GTR9: Headform Area Split

Dirk-Uwe Gehring
BGS Böhme & Gehring GmbH

03 December 2021

Figure 11: Example of marking of HIC1000 zone and HIC1700 zone

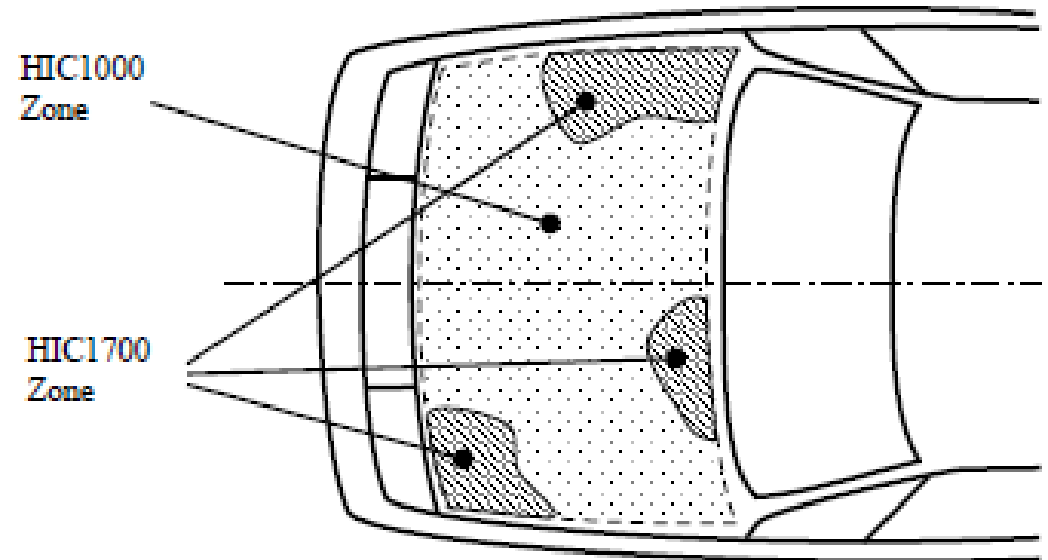
- Fig. 11 is only referred to in 3.7, i.e. the dotted line is the whole bonnet top, **not** the combined child and adult impact area
- => No WAD 1000, no WAD 2100
- No 82.5 mm distances
- No 1/3 – 2/3 rule for this figure

GTR9 – Examples of the „combined test area“

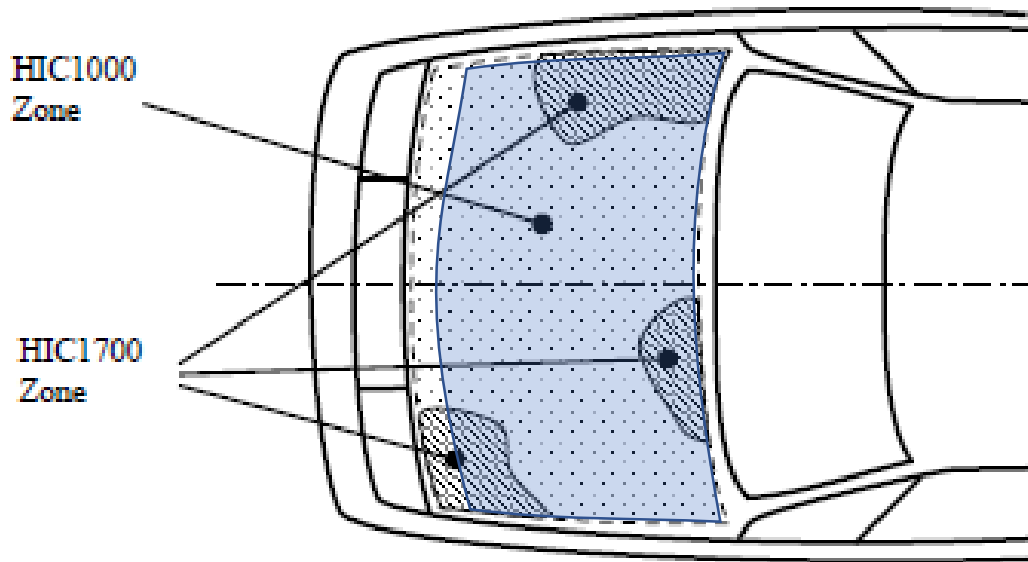
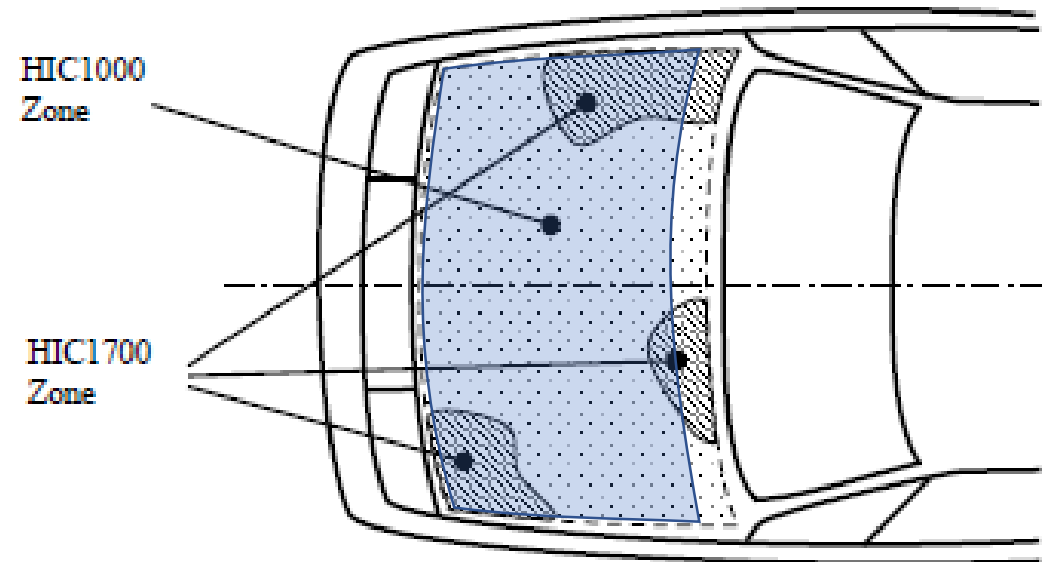
In every case there are parts of the HIC 1000 zone up to the test area borders!

GTR9 – Testable headform area (example)

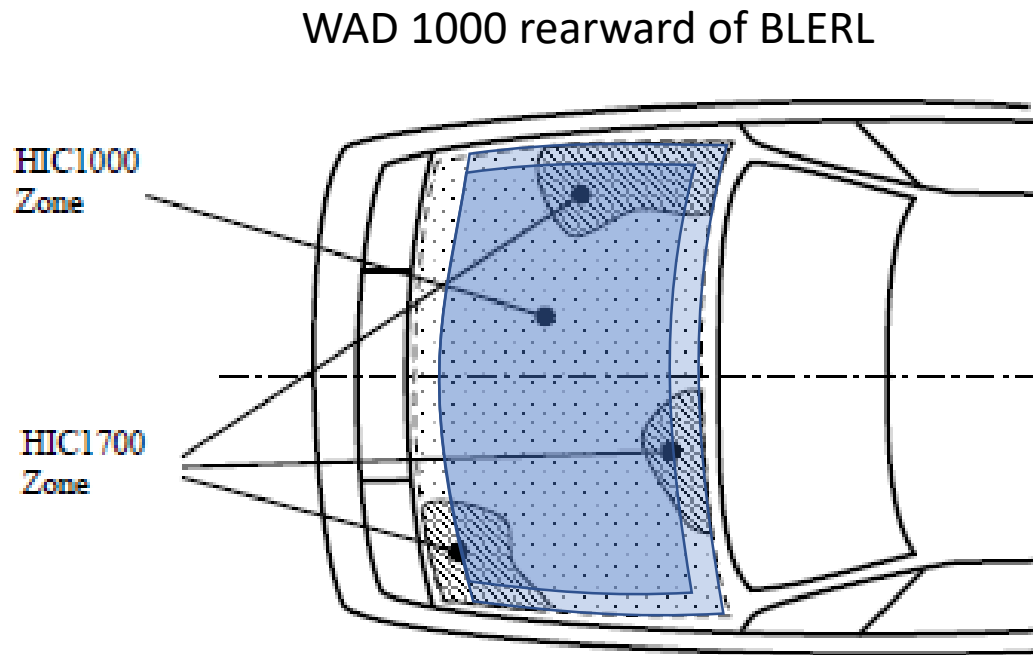
- GTR 9 allows the HIC 1000 zones to exceed the testable area
- The manufacturer may allocate parts of the HIC 1000 zones to untestable parts of the combined impact area
- These allocations cannot be verified

- GTR 9 must be amended to ensure that the 1/3-2/3 requirement can be verified , i.e. that it is only related to the testable part of the impact area.
